FJC | Melrose Park South - East Precinct Block 6 - SSDA Drawing Set Response to Submissions (RTS)

MELROSE PARK SOUTH | EAST PRECINCT BLOCK 6
DARUG
MELROSE PARK - BLOCK B6
MELROSE NSW 2114

Sheet No.
1995

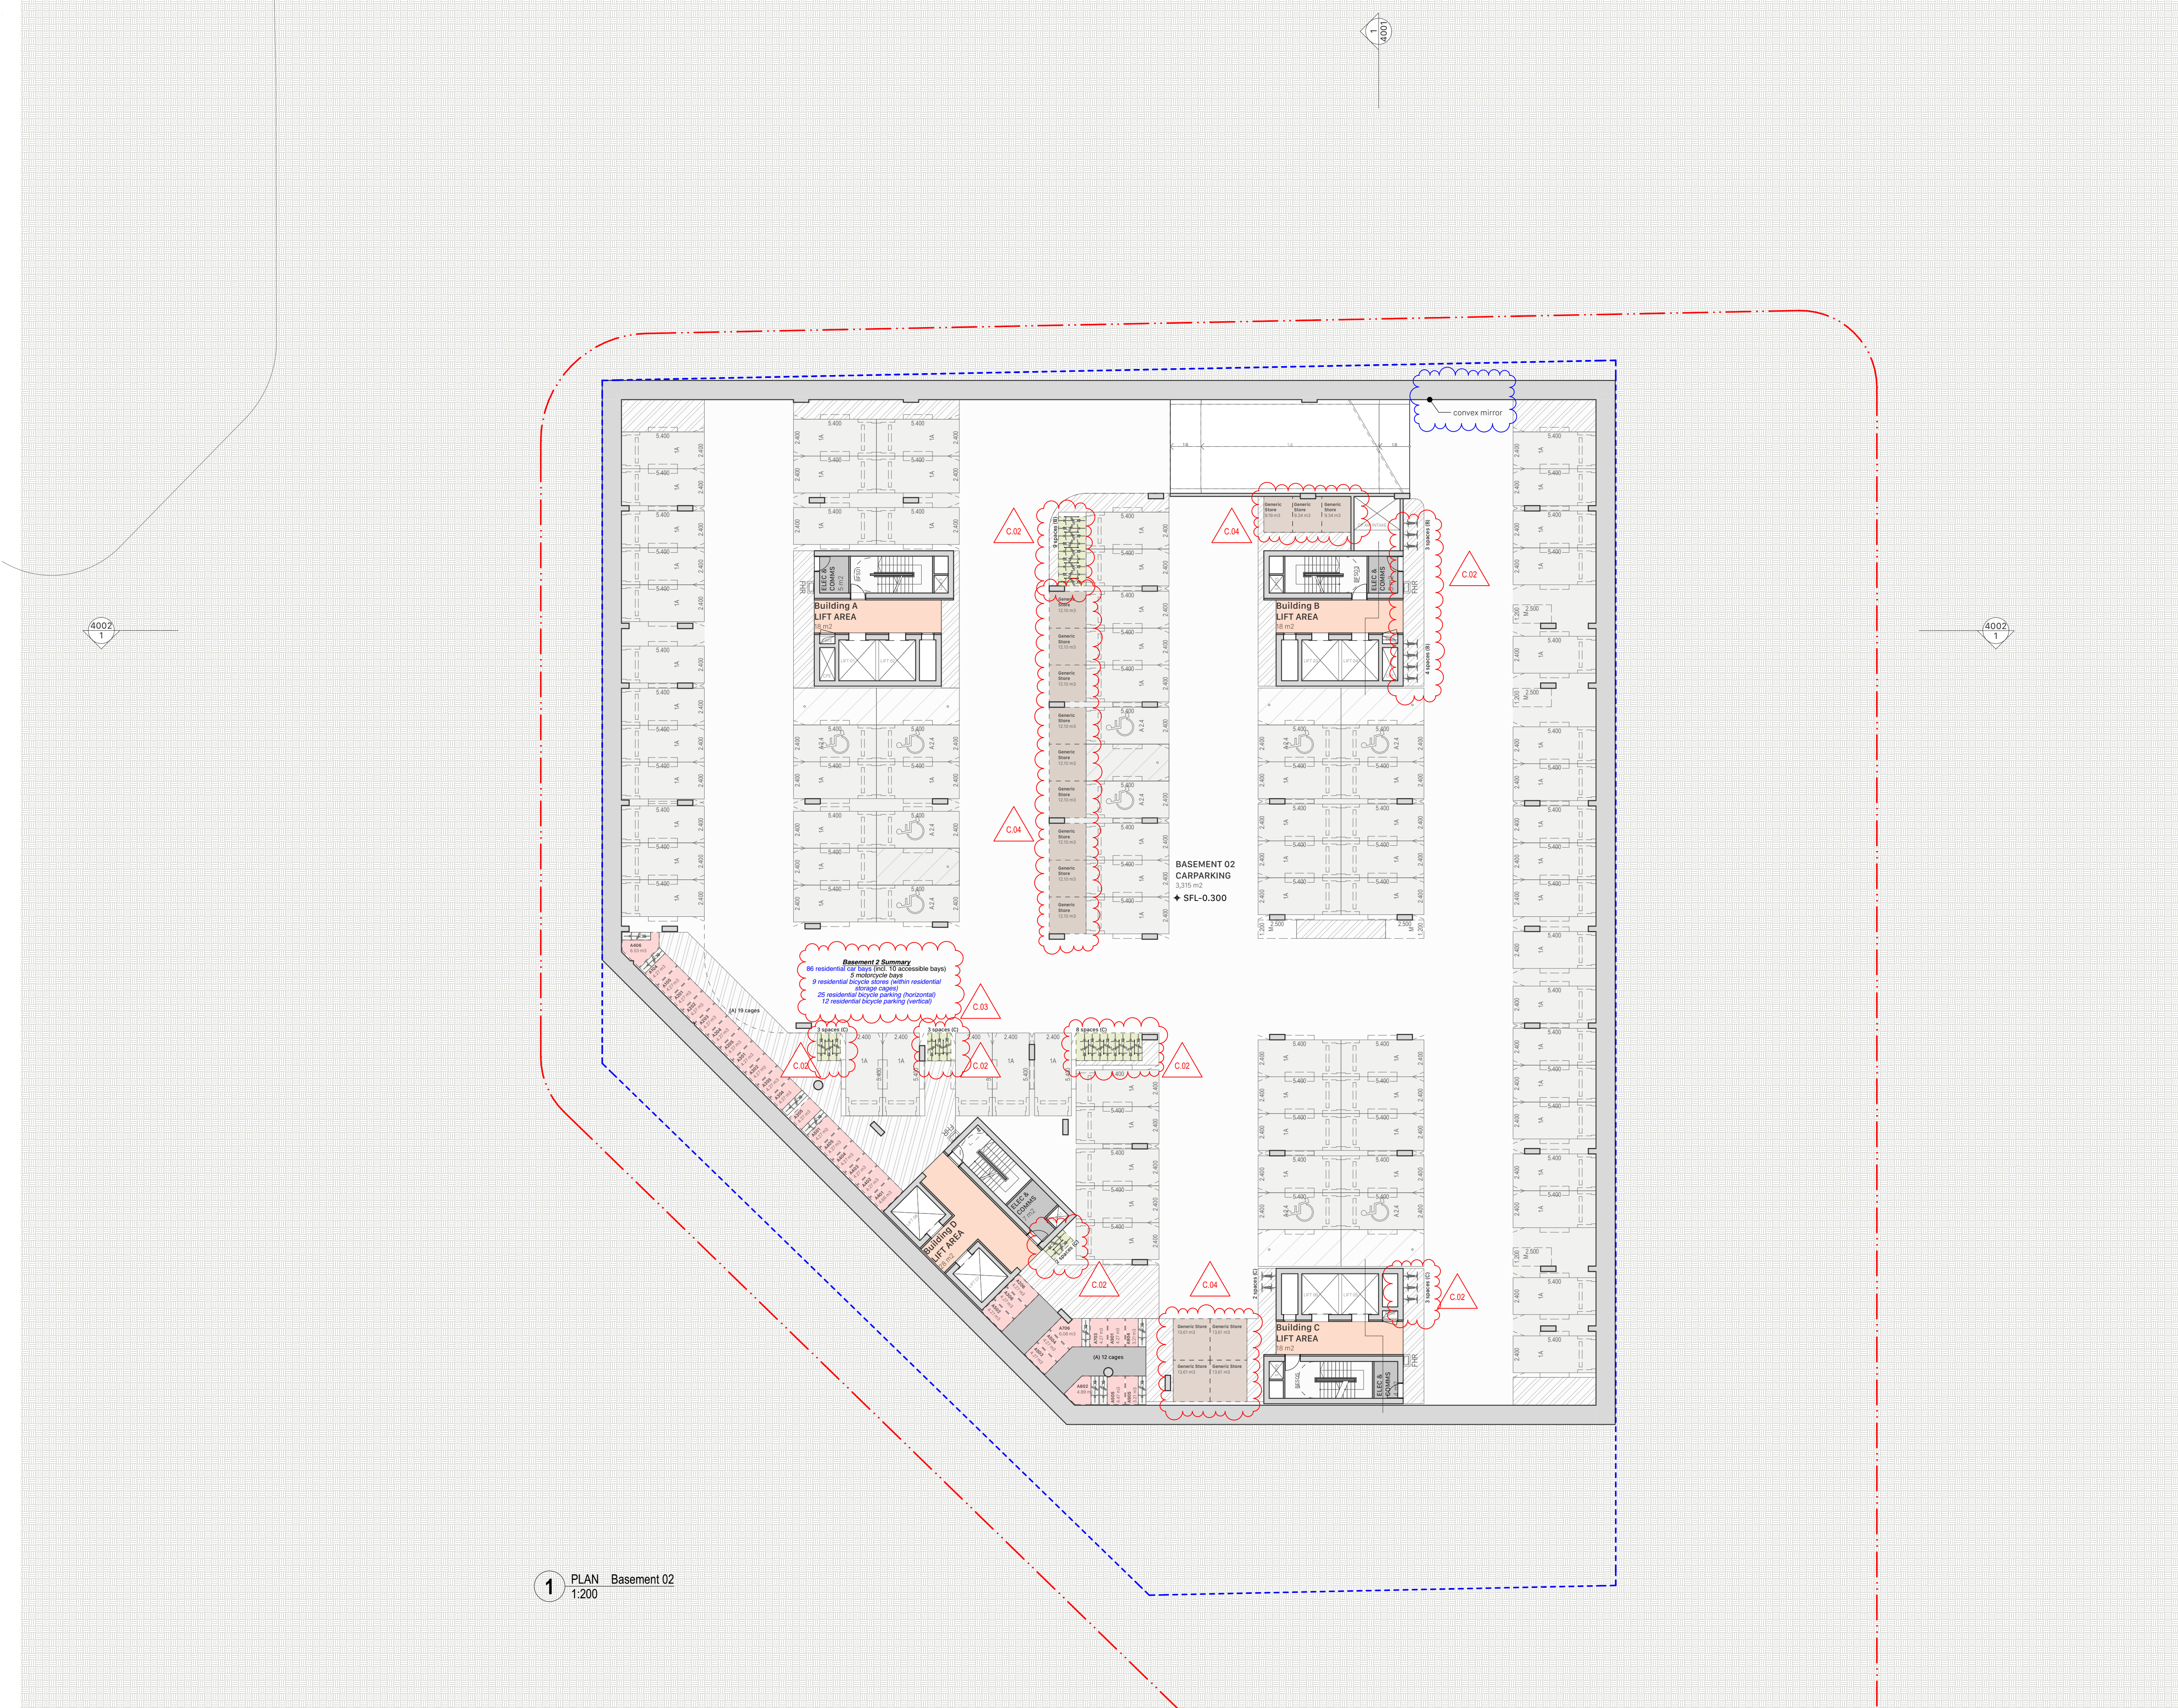
SUMMARY OF CHANGES (RTS)

C.02 NEW RESIDENTIAL BICYCLE PARKING AREA

C.03 UPDATED BICYCLE PARKING AND RESIDENTIAL STORAGE CAGE SUMMARY

C.04 PARKING SPACES REPLACED WITH STORAGE CAGES

CONVEX MIRROR PLACED PER TTPP'S ADVICE, VISIBLE ON SSDA SUBMISSION DRAWINGS

GENERAL NOTE:
RESIDENTIAL STORAGE CAGES NOW ALLOCATED TO INDIVIDUAL APARTMENTS. PLEASE REFER IN CONJUNCTION WITH THIS DOCUMENT- SSDA-FJC-9900 SOUS ADG Compliance Schedule [Rev03]

Sheet No.
1997
Rev
C

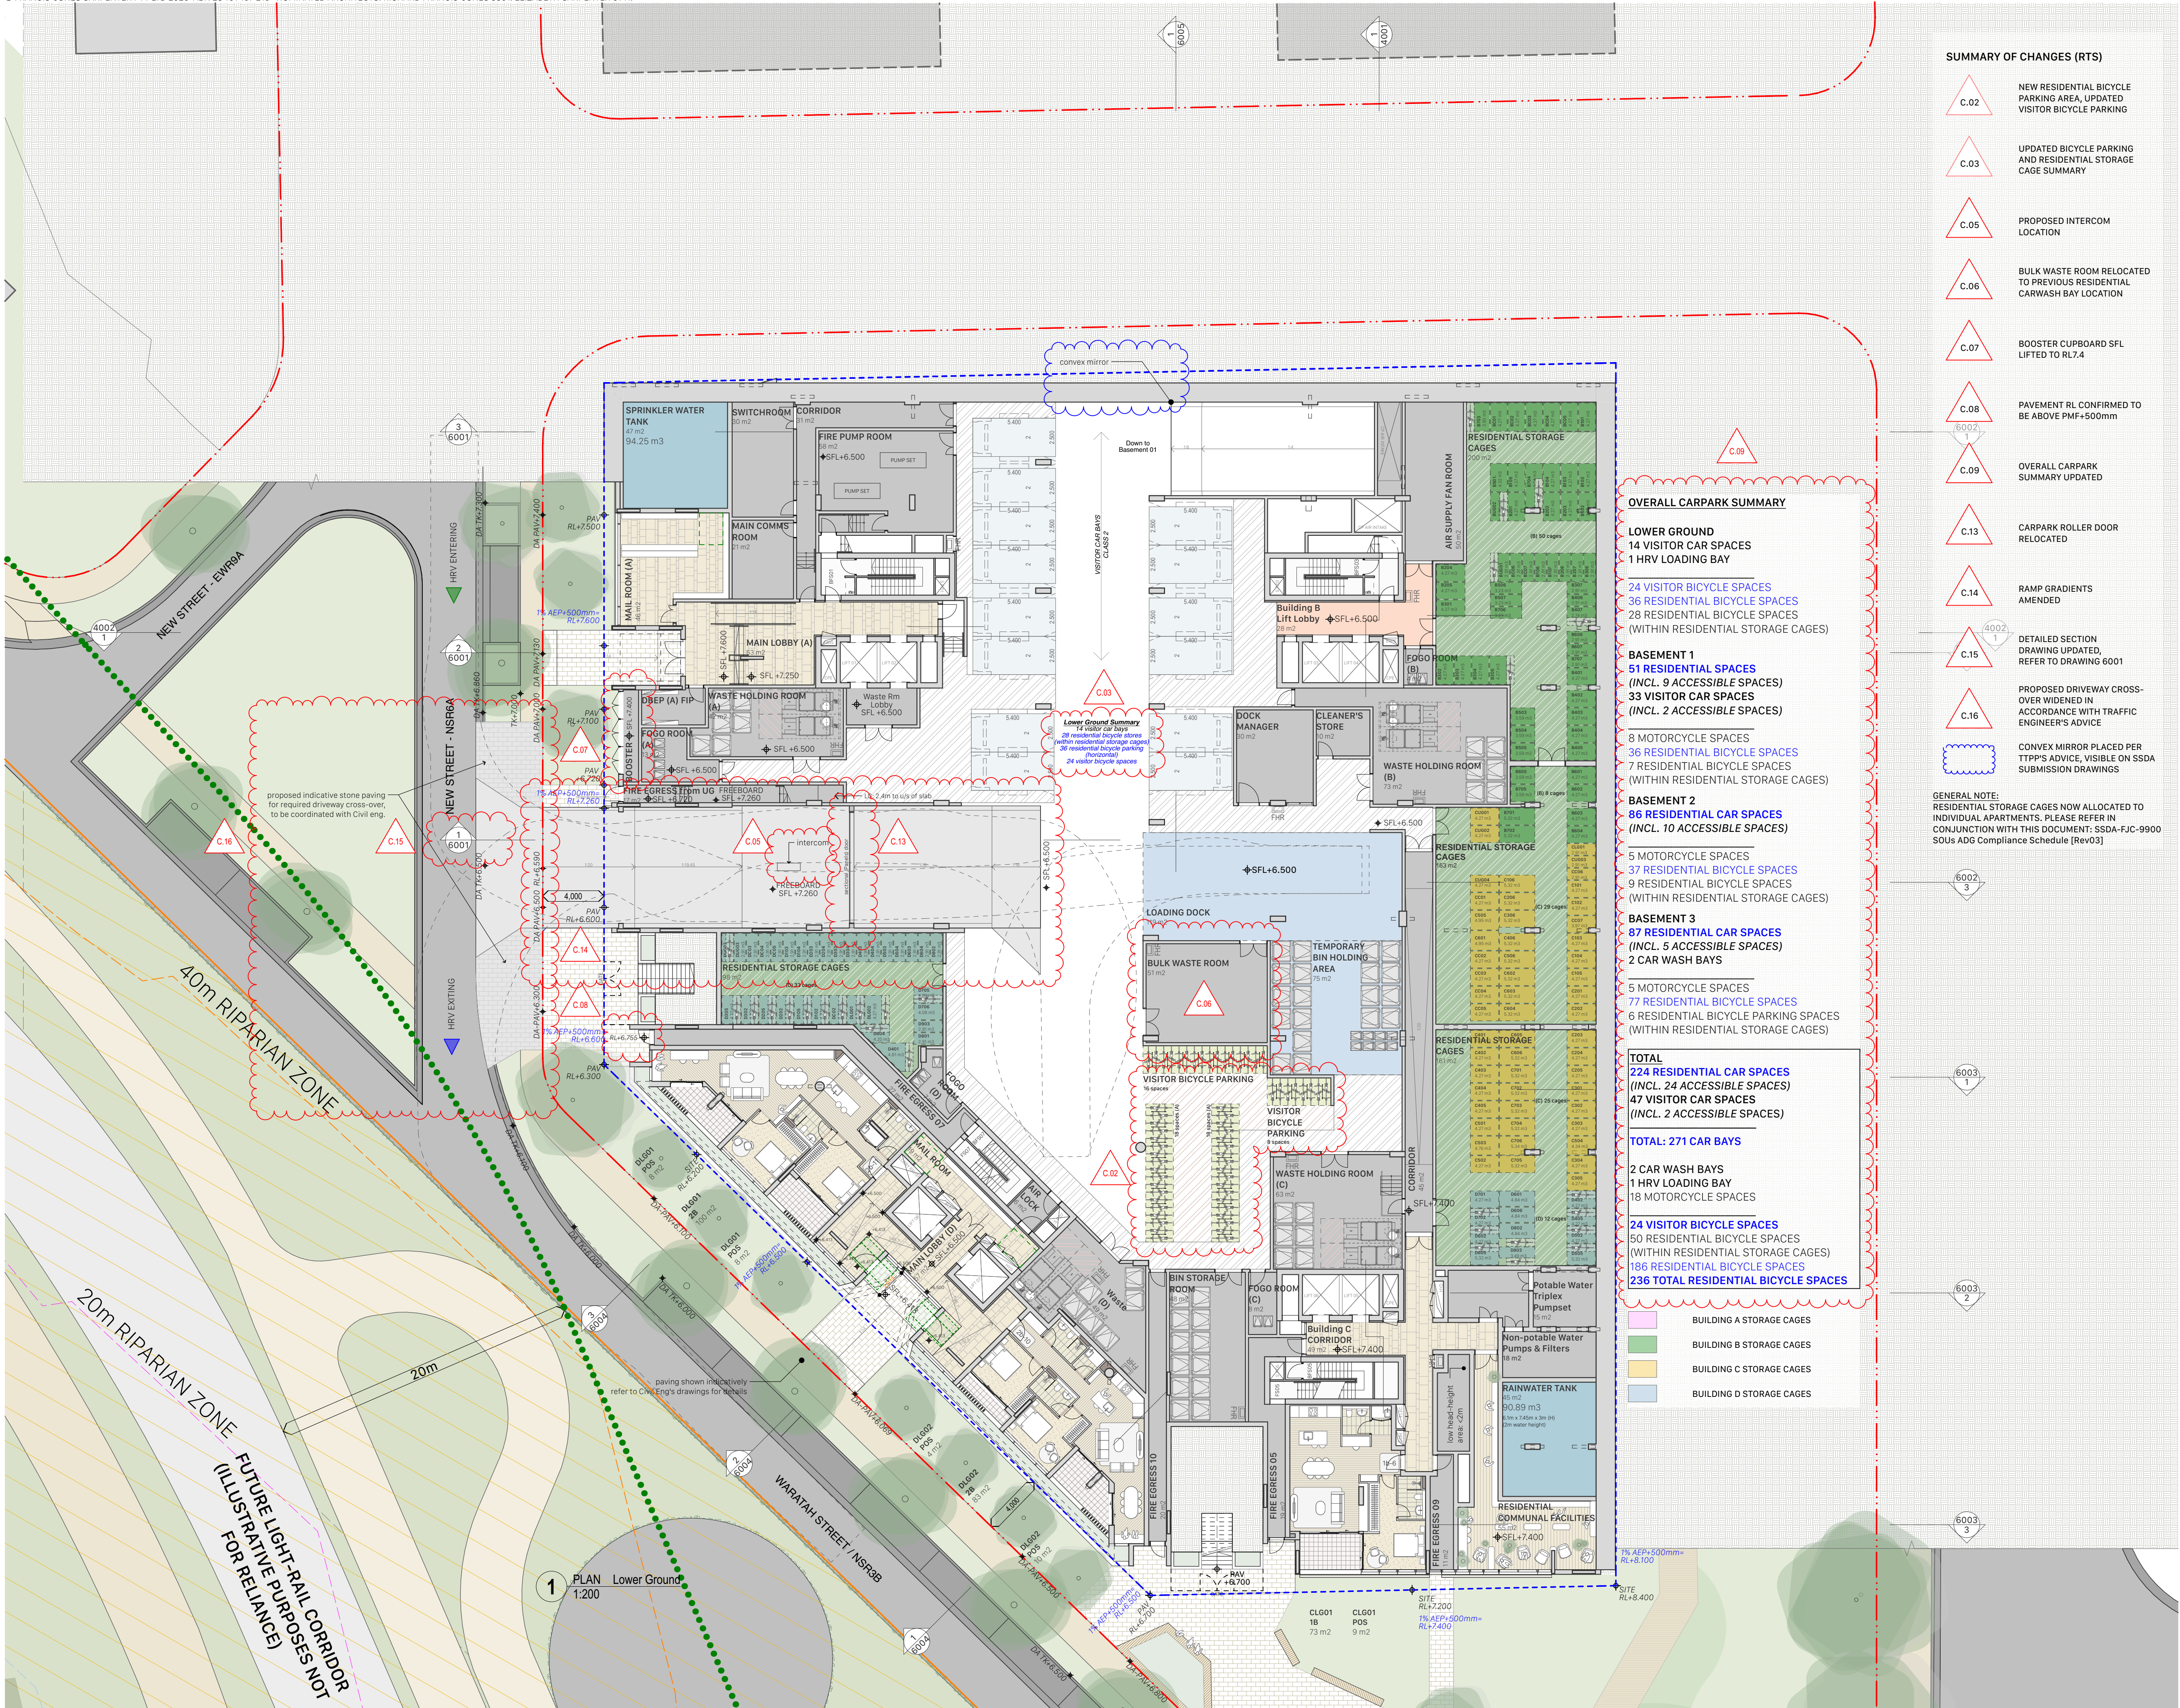
SUMMARY OF CHANGES (RTS)

C.02 NEW RESIDENTIAL
BICYCLE PARKING AREA

C.03 UPDATED BICYCLE PARKING
AND RESIDENTIAL STORAGE
CAGE SUMMARY

C.04 PARKING SPACES REPLACED
WITH STORAGE CAGES

C.17 WHEELSTOPS REMOVED
FROM PARALLEL
PARKING SPACES

CONVEX MIRROR PLACED PER
TTPP'S ADVICE, VISIBLE ON SSDA
SUBMISSION DRAWINGS

Sheet No. Rev
1999 C

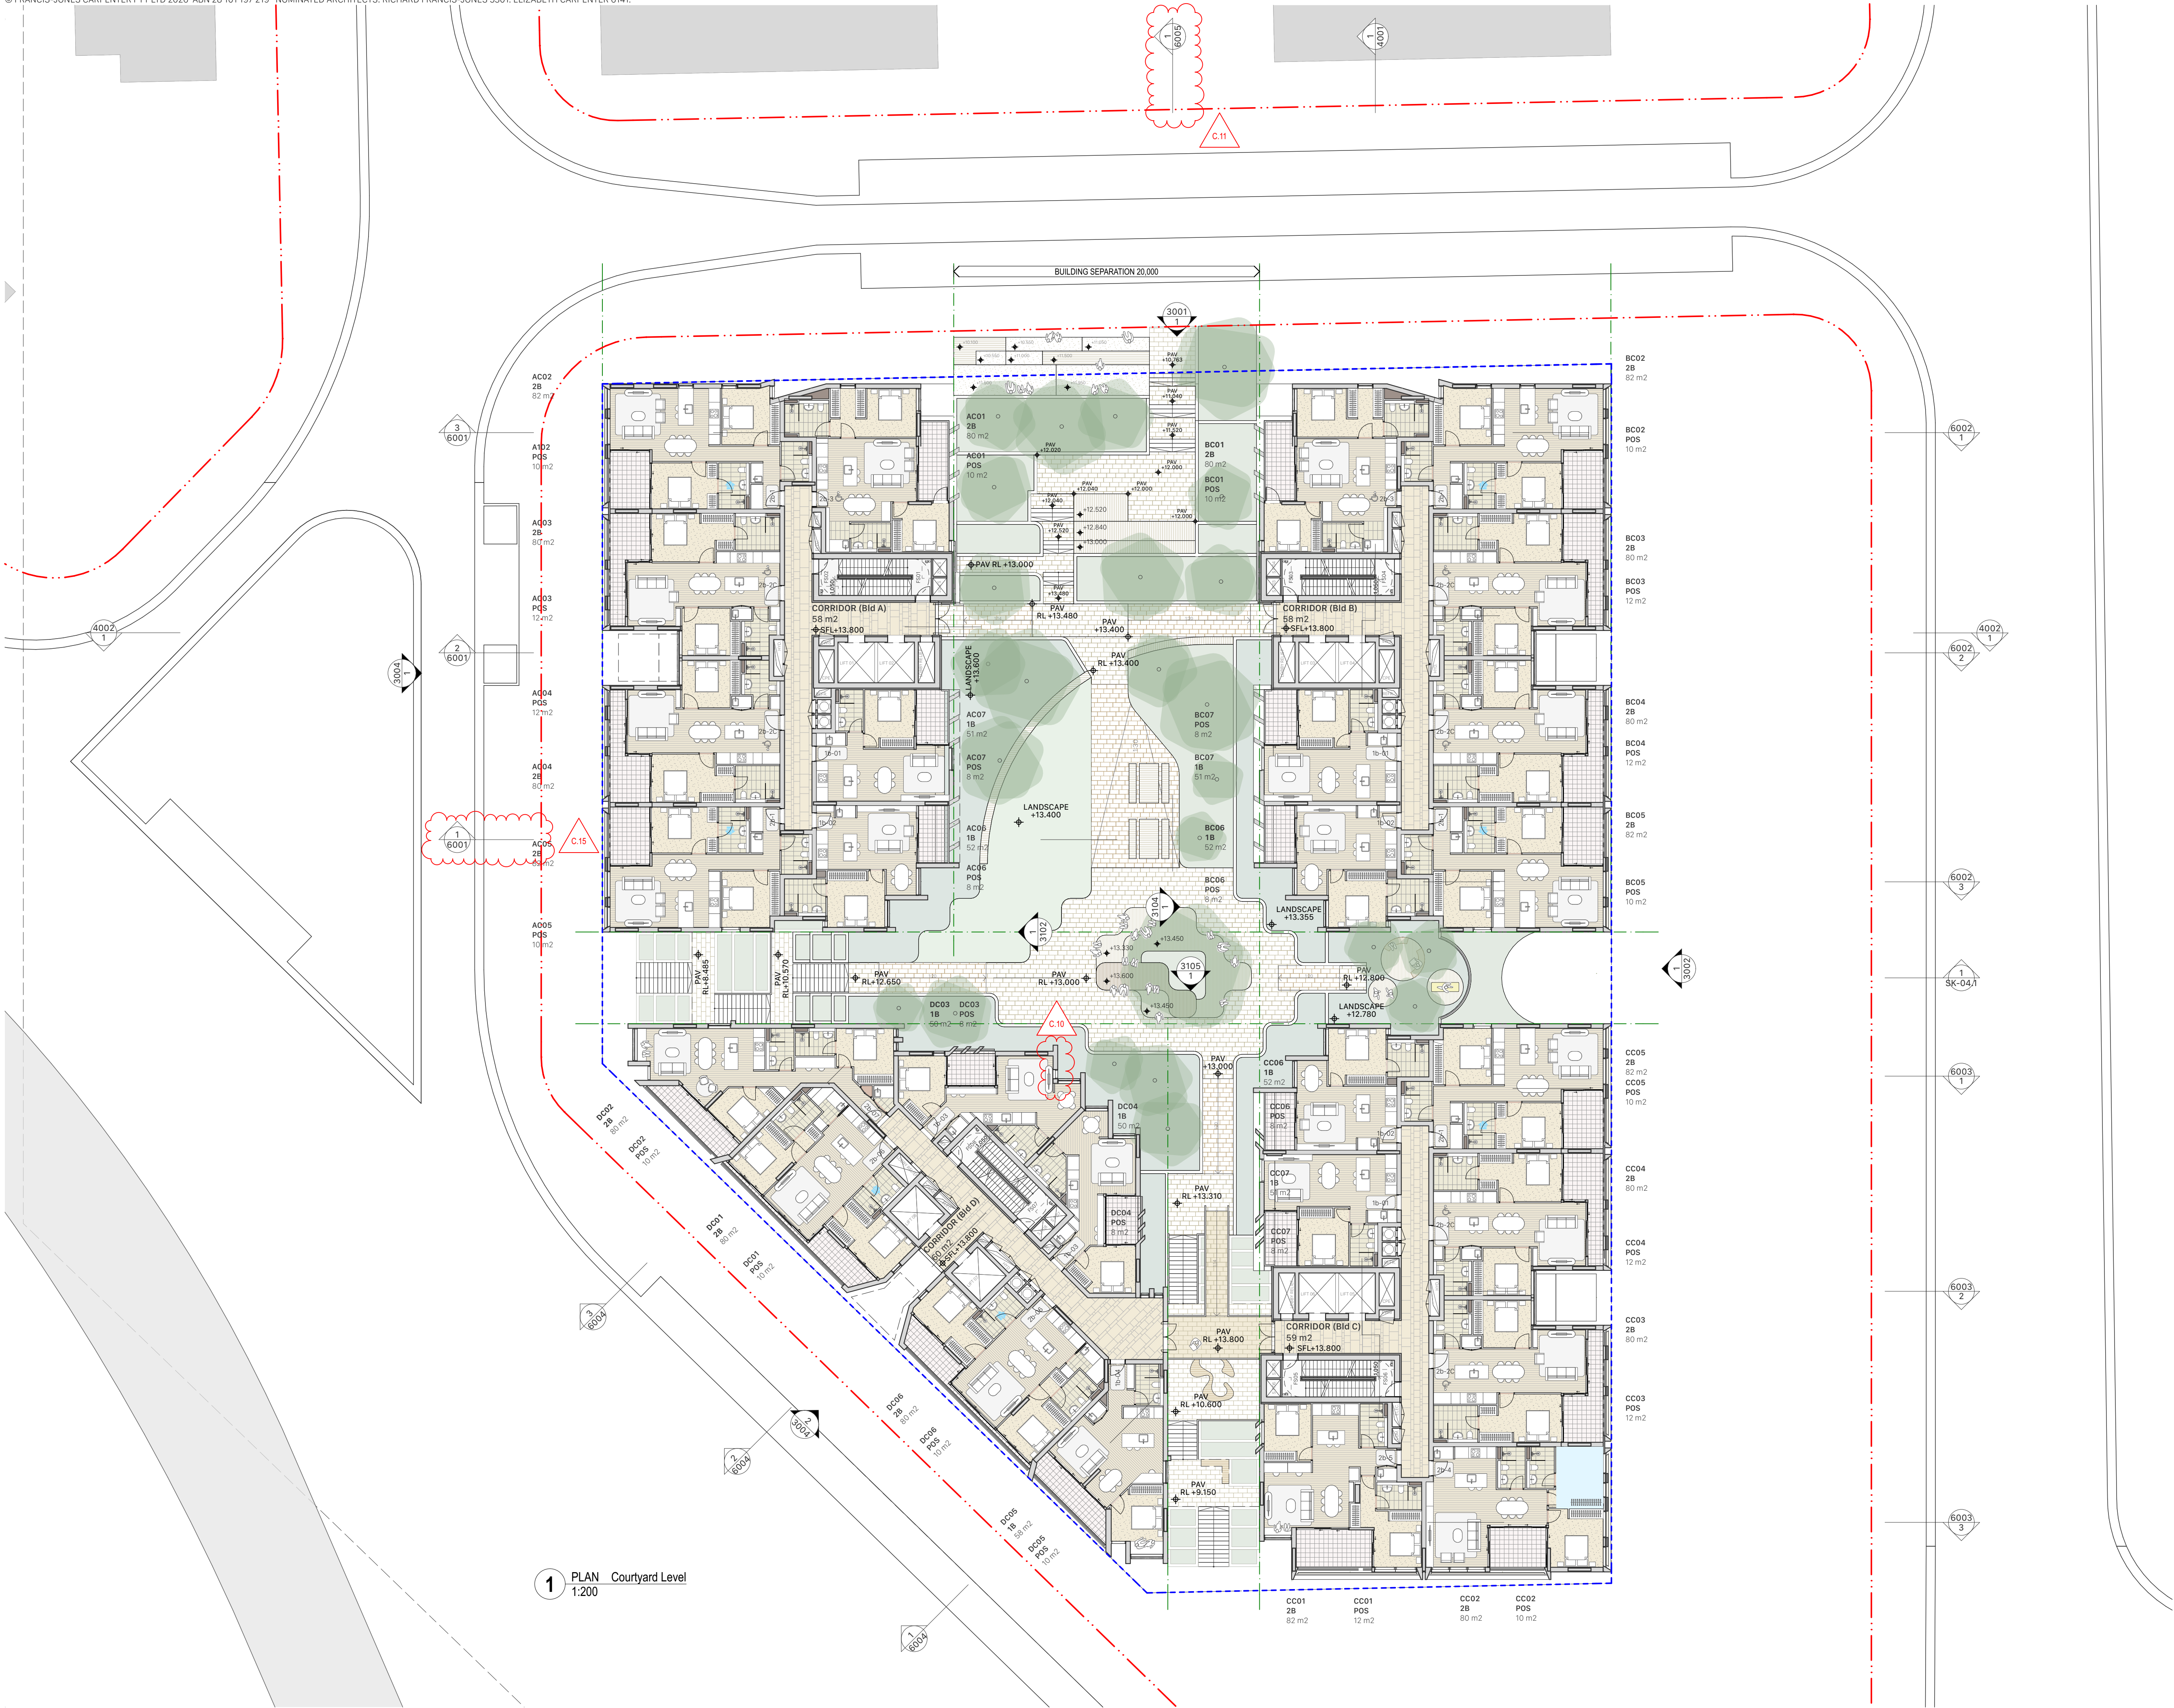
- SUMMARY OF CHANGES (RTS)**
- NEW CROSS SECTION THROUGH NORTHERN COURTYARD AND EWR9. REFER TO DRAWING 6005
 - DETAILED SECTION DRAWING UPDATED, REFER TO DRAWING 6001
